Subject: Duke Power Company LLC
Oconee Nuclear Station, Unit 3
Docket Nos. 50-287
Third Ten Year Inservice Inspection Interval
Request for Relief No. 05-ON-002, Rev 1

Request for Additional Information
With Response Re:

05-ON-002

TECHNICAL LETTER REPORT
REQUEST FOR ADDITIONAL INFORMATION
ON THIRD 10-YEAR INSERVICE INSPECTION INTERVAL
REQUEST FOR RELIEF 05-ON-002
FOR
DUKE POWER COMPANY
OCONEE NUCLEAR STATION, UNIT 3
DOCKET NUMBER 50-287

(W4)
3-RPV-WR34
B01.011.004

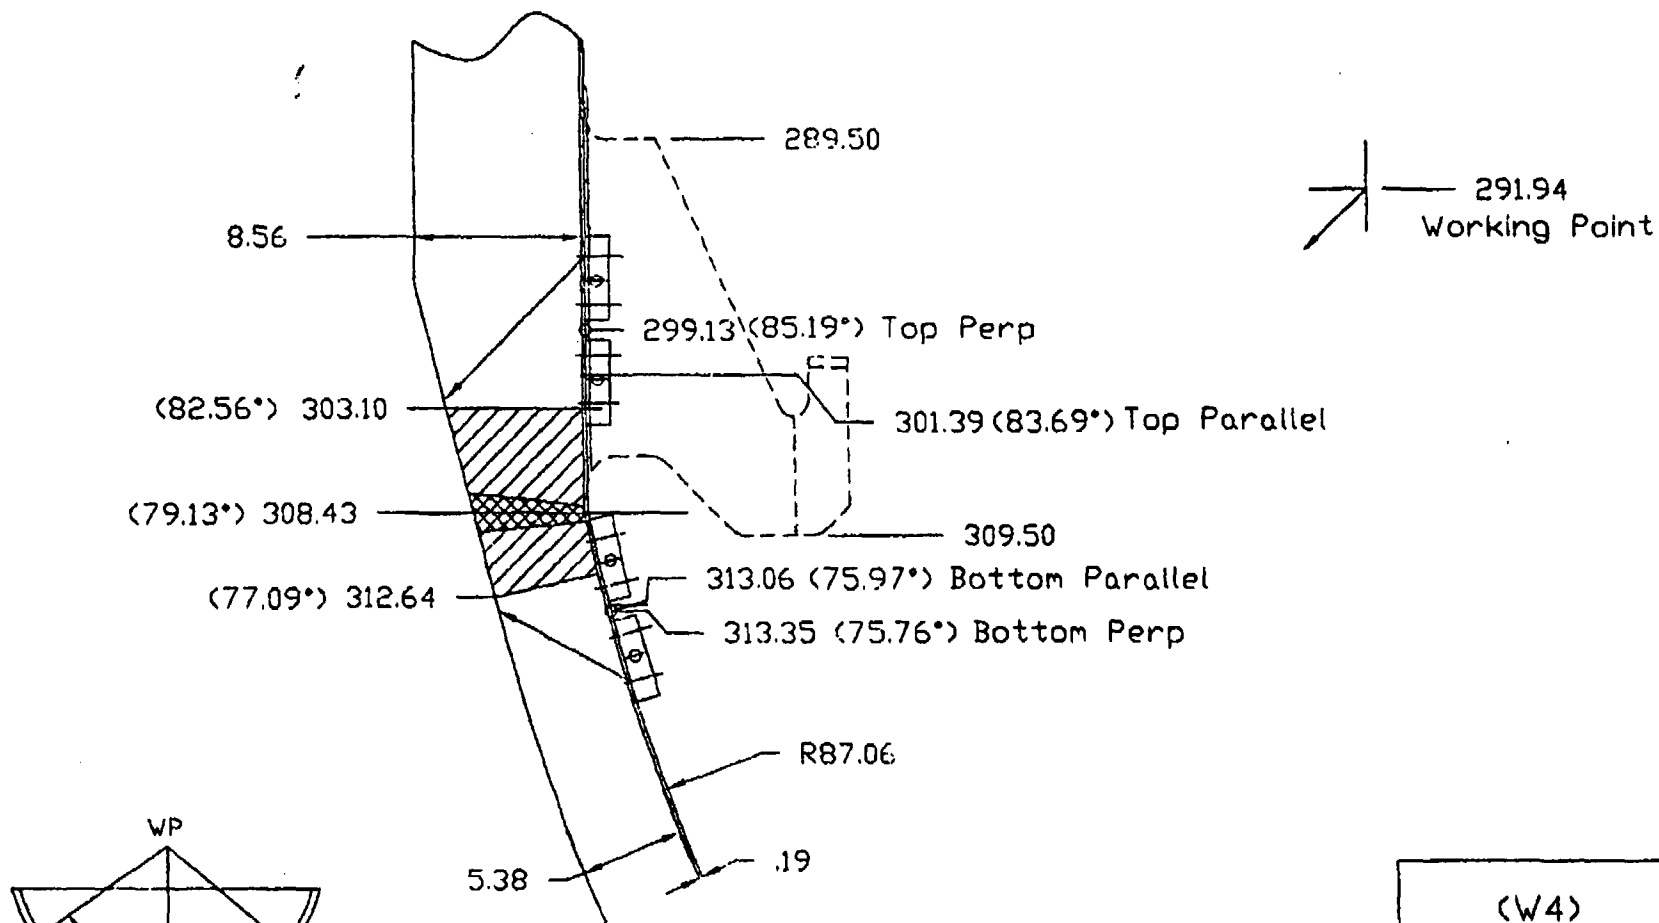
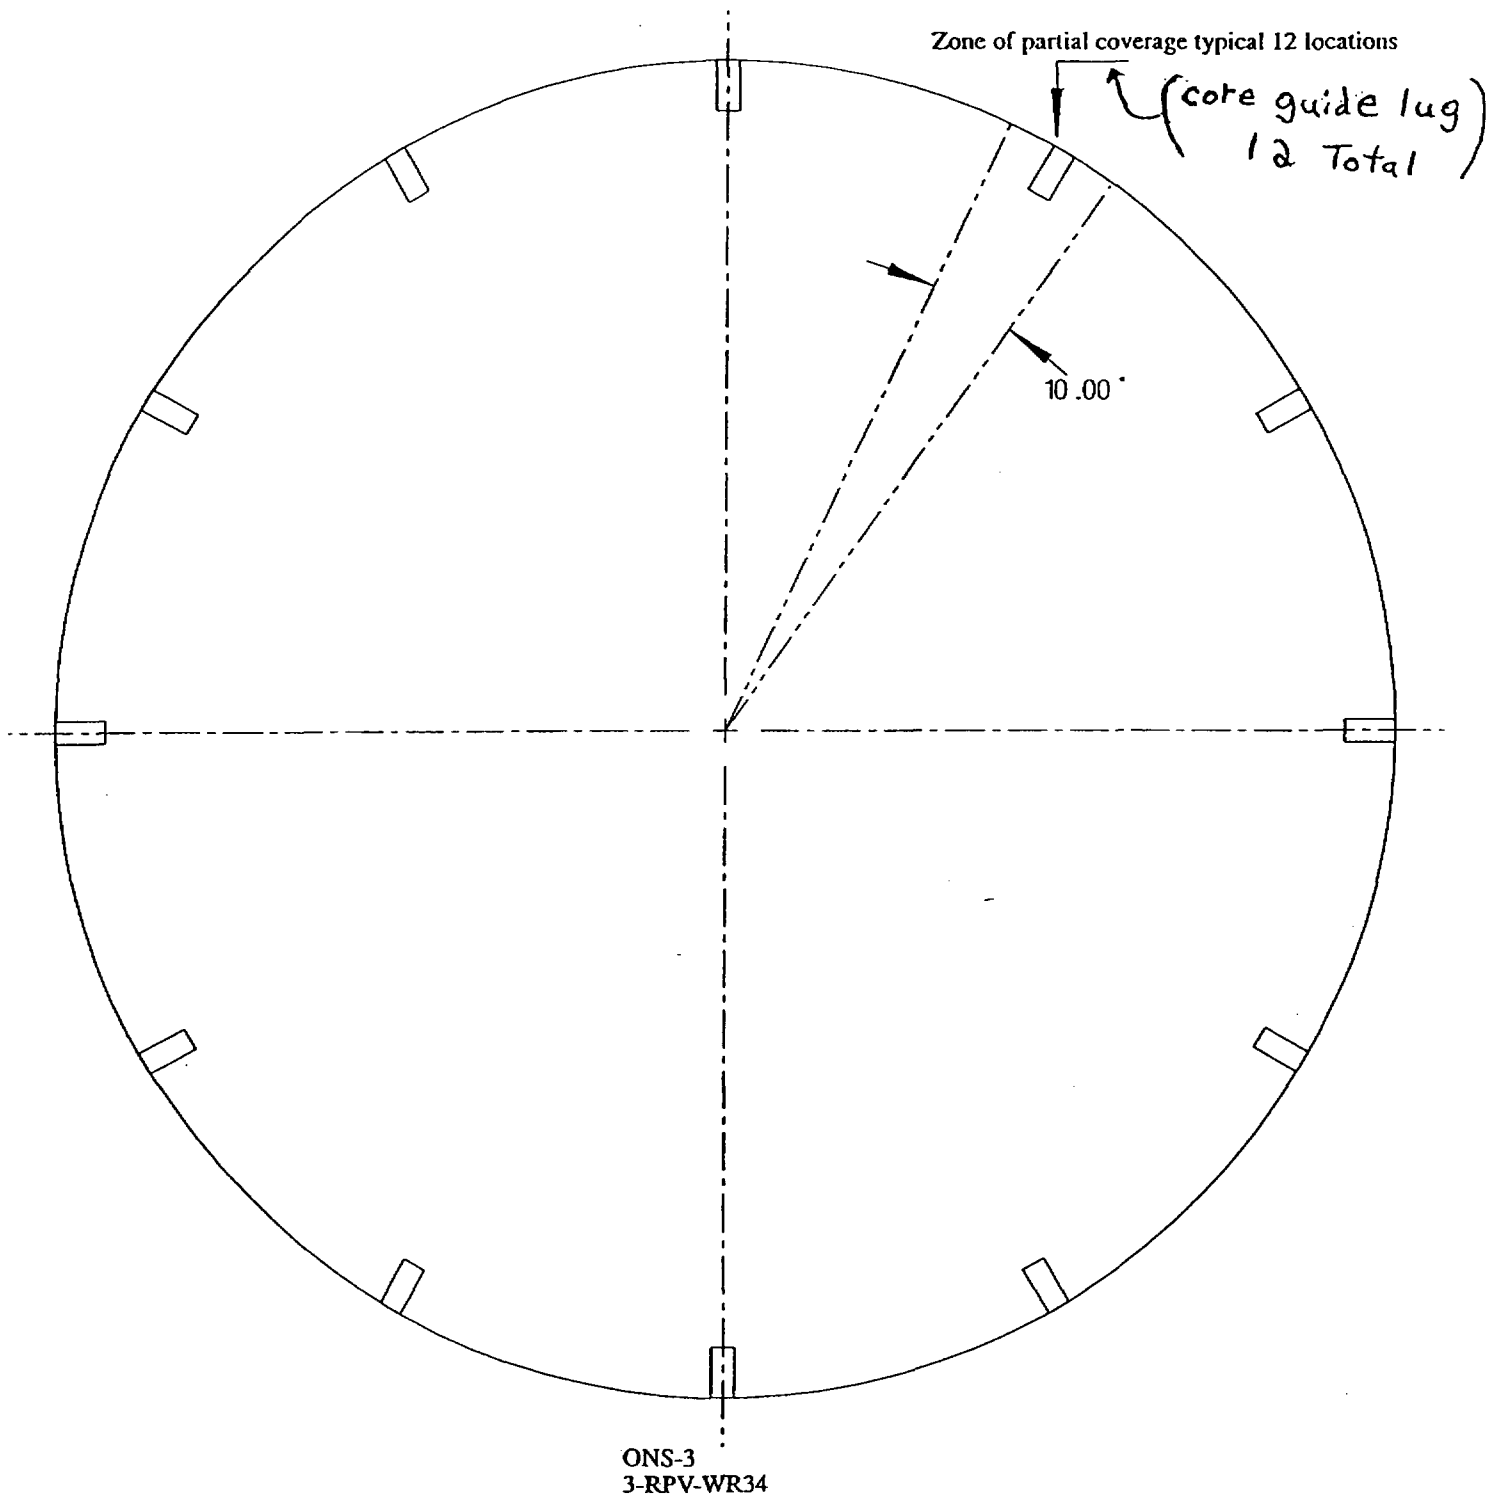
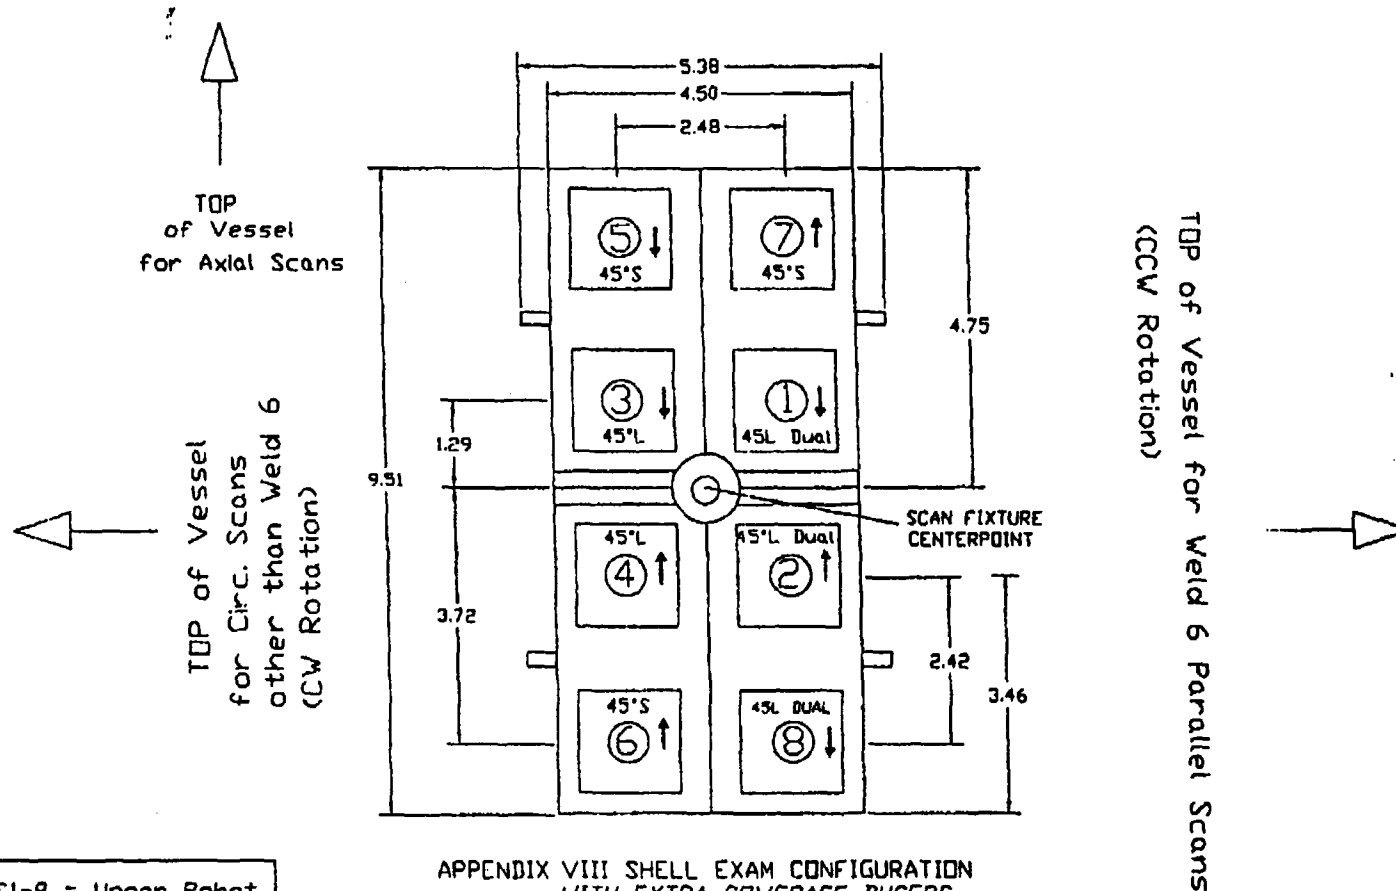
- 2.2(a) For RPV shell-to-lower head Weld 3-RPV-WR34, the licensee stated that core support/guide lugs caused restrictions to the scanning access for these welds. Please be more specific as to how the RPV appurtenances restrict scanning access. Describe the remote UT fixture, including the transducer sled dimensions, and how the guide lugs prevented placing the transducer sled in a proper position for performing the examinations. Provide similar information for lower head ring Weld 3-RPV-WR35.

For weld 3-RPV-WR34:

Pages 2 of 4 and 4 of 4 were added to attachment B that should help to answer the question.

(note: Page 2 of 4 should have been sent with the original request for relief but may have been lost during the transmittal process. Page 4 of 4 is a new page.)

During ultrasonic examination, 100% coverage of the required examination volume could not be obtained. Twelve core guide lugs restrict the scanning surface, as shown on the Attachment B drawing, causing limitations that resulted in 44.5% coverage. The percentage of coverage reported represents the aggregate coverage from all scans parallel and perpendicular to the weld. The weld and adjacent base material were examined using 45° refracted shear waves and 45° refracted longitudinal waves. Examination volumes directly below the core guide lugs received no coverage when scanned parallel to the weld. Additionally no scans were performed perpendicular to the weld directly below the core guide lugs. Scans parallel to the weld were restricted to 7.6 inches on either side of each core guide lug and scans perpendicular to the weld were restricted to 4.7 inches on either side of each core guide lug. In order to achieve more coverage, the core guide lugs would have to be moved to allow greater access, which is impractical. There were no recordable indications found in the areas that were examined.
